Project: R14-06-051 Wagner Glass Rail Base Shoe – Compliance with Alberta Building Code 2014

We have reviewed the structural design of the Panel Grip 2 Base Shoe GR2457HCB for compliance with the Alberta Building Code 2014.

Figure 1: Glass Height

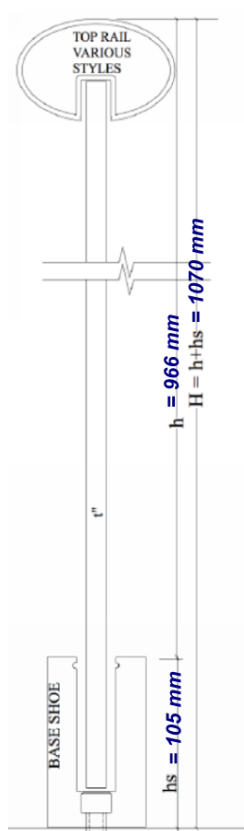
- 8.) The glass height above the base shoe is 966 mm (38.03 in) and the heights from top of top rail to bottom of base shoe is 1070 mm (42.13 in).
